**Section 16 Planning Application for Proposed Minor Relaxation of  
Building Height and Plot Ratio Restrictions  
for Permitted Public Housing Development at  
Long Bin, Yuen Long  
(Application no. A/YL-TYST/1285)**

**S.16 Application No. A/YL-TYST/1285**

**Responses to Comments**

DRAWING NO.  
YL43/2&3/S16/4

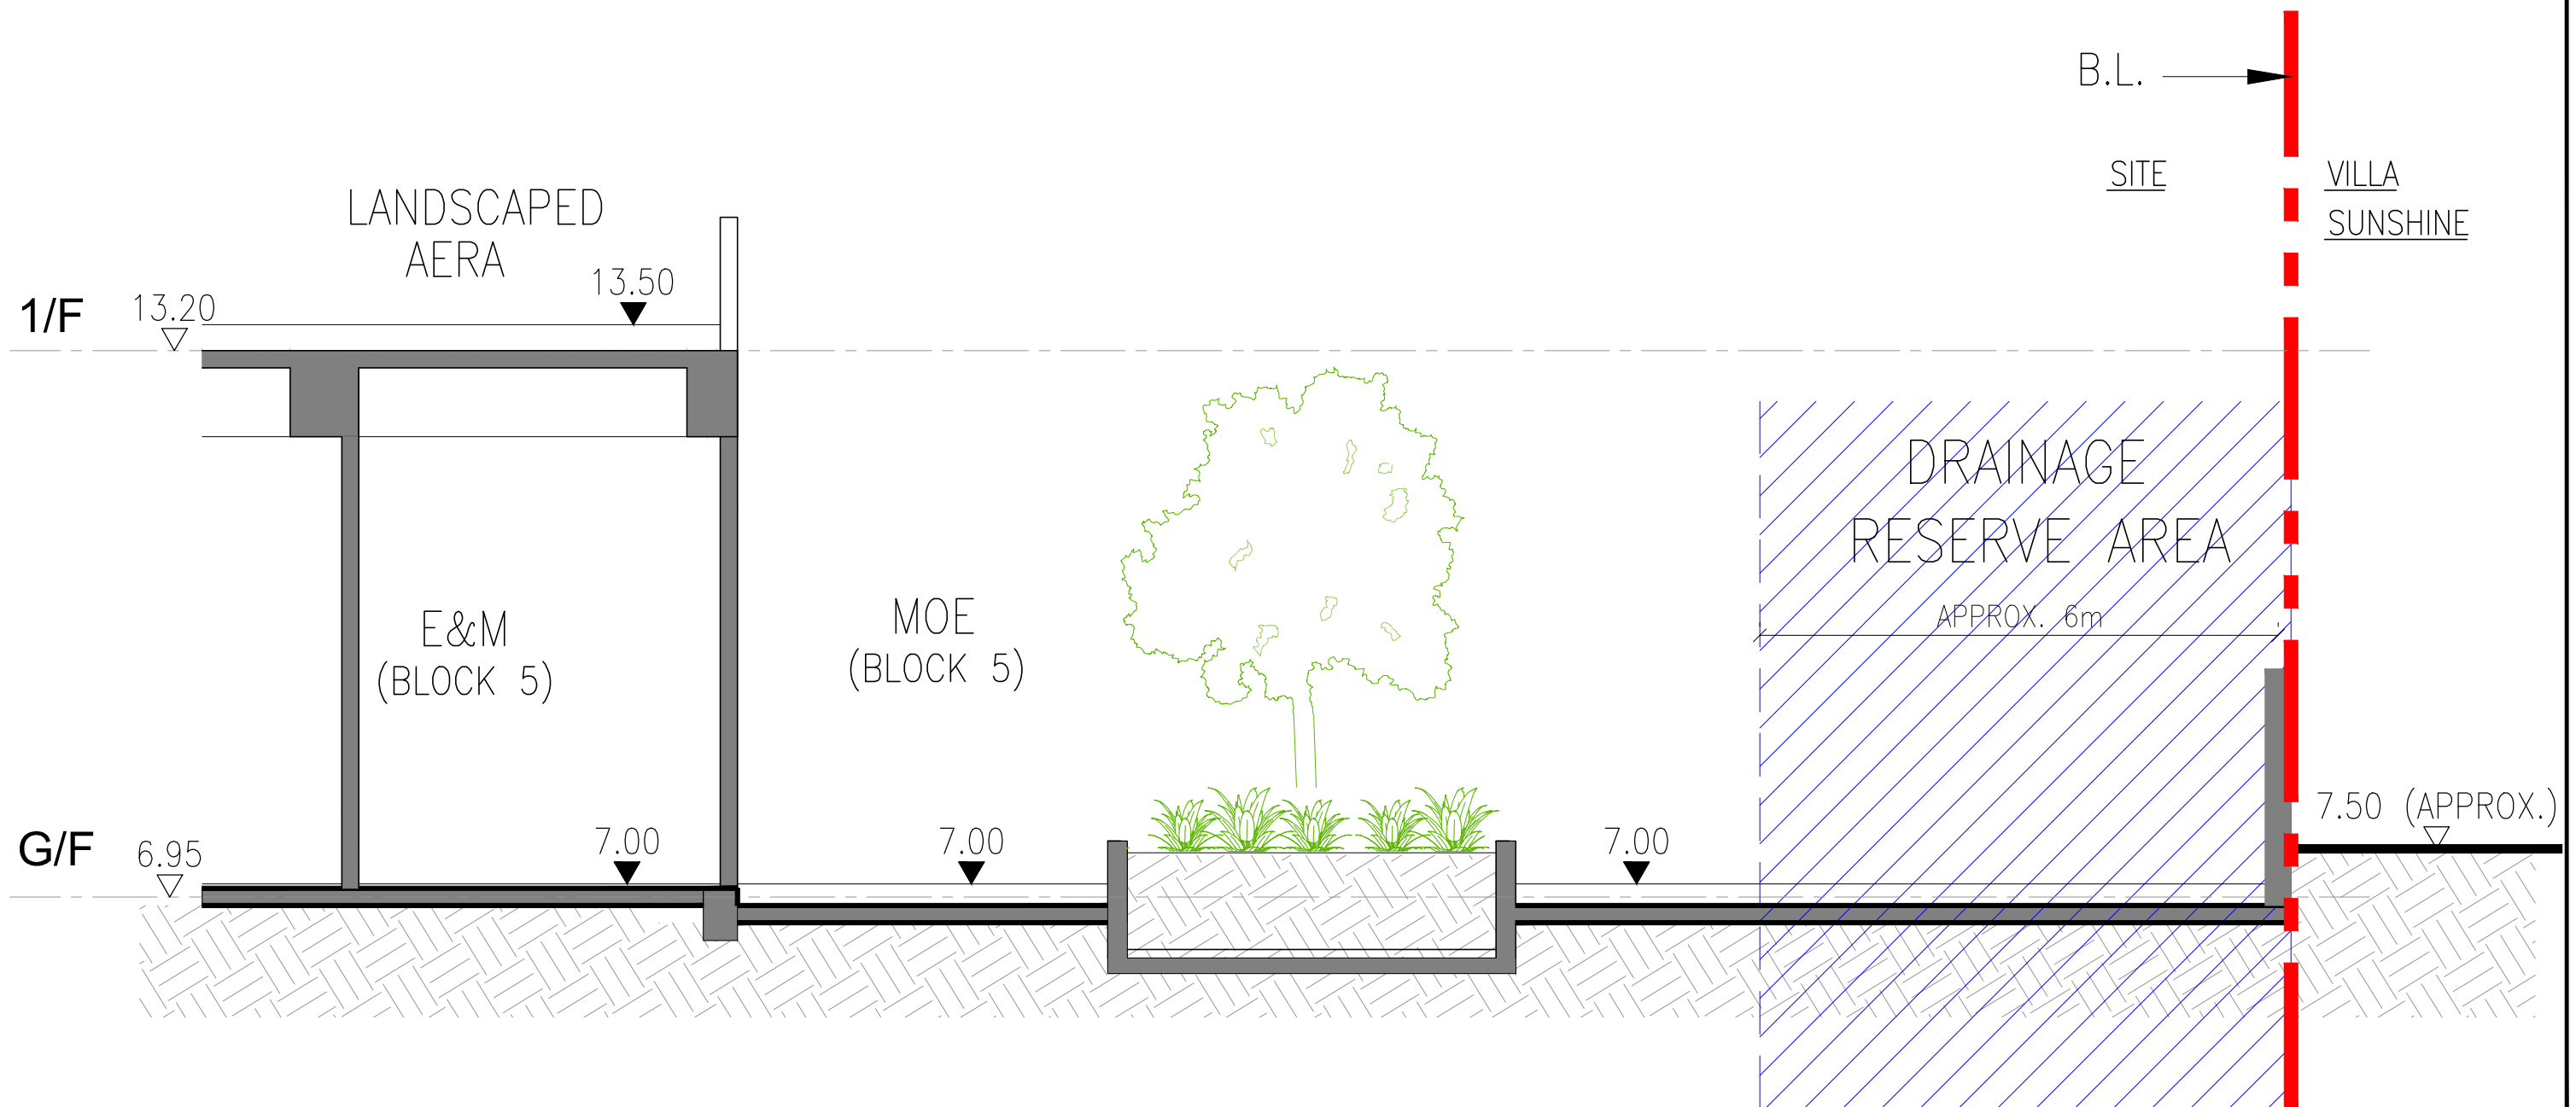
(c) Please provide scale bar on the Indicative Landscape Master Plans.	Noted. Please refer to the revised Indicative Landscape Master Plans (Figures 5 to 8) in <b>Attachment 4</b> .

Figure 1

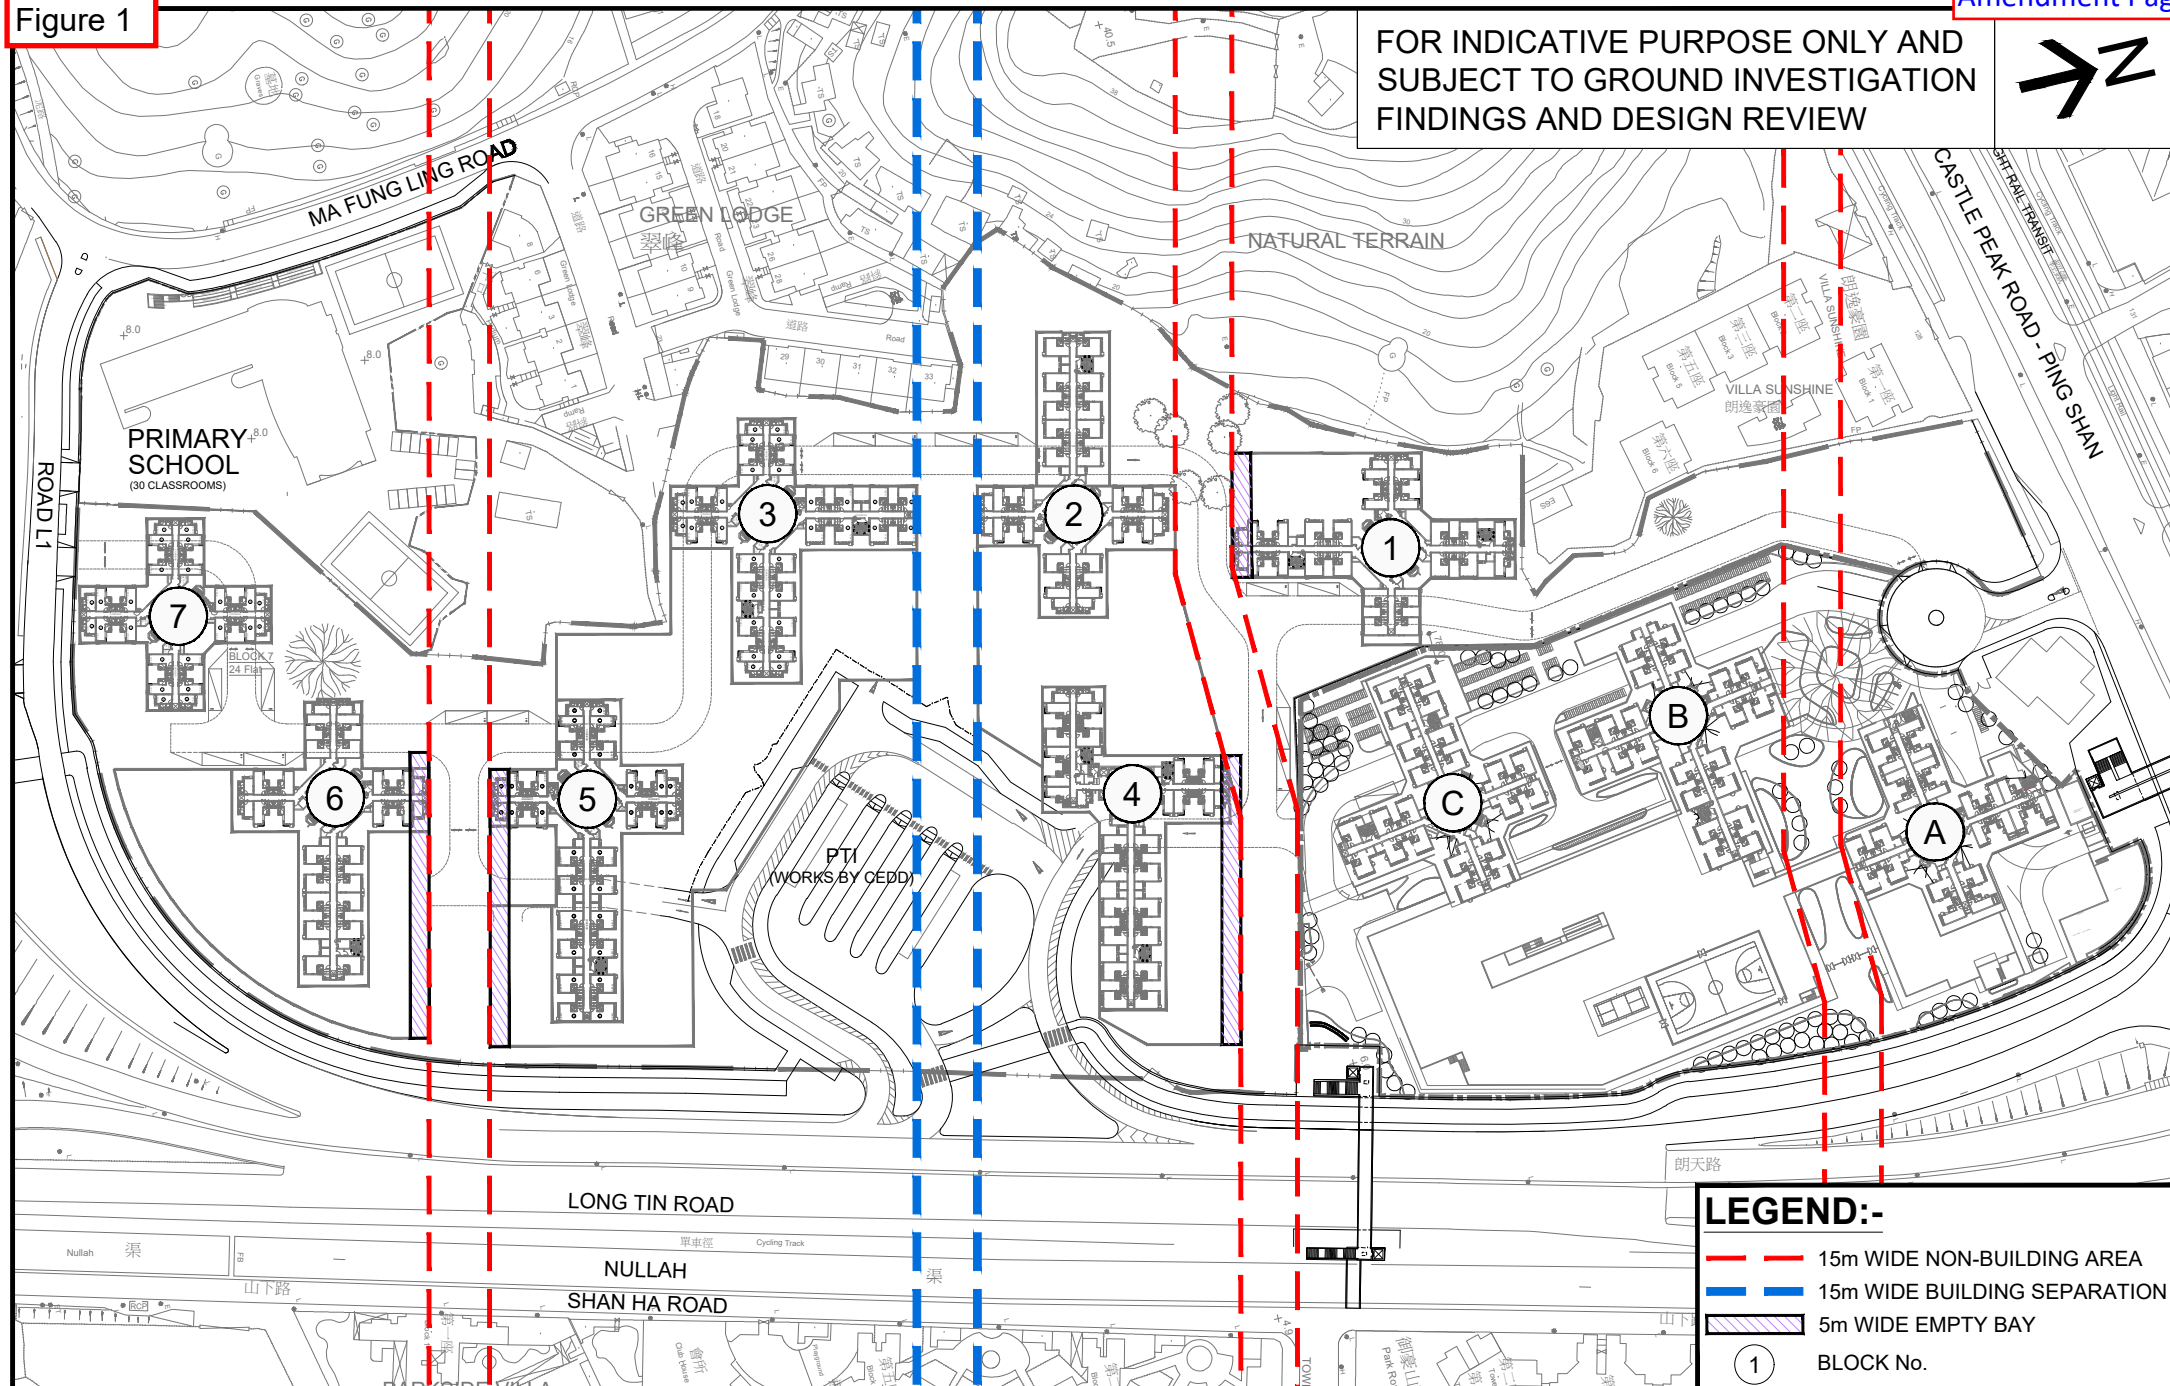
Comments	Responses
	/ Retail / Educational and Other Supporting Facilities”.	
	<p><u>Figure 1 of the Qualitative Statement on Air Ventilation Assessment and Plans 2 to 10 of the Qualitative Statement On Visual Impact Assessment</u></p> <p>- Please replace the phrase “Current Scheme” to “Approved s.16 Application No. A/YL-TYST/1074 (Current Scheme)” for clarity.</p>	<p>Noted. Please refer to the revised Figure 1 of the Qualitative Statement on Air Ventilation Assessment in <b>Attachment 5</b> and the revised Plans 2 to 10 of the Qualitative Statement On Visual Impact Assessment in <b>Attachment 7</b> respectively.</p>
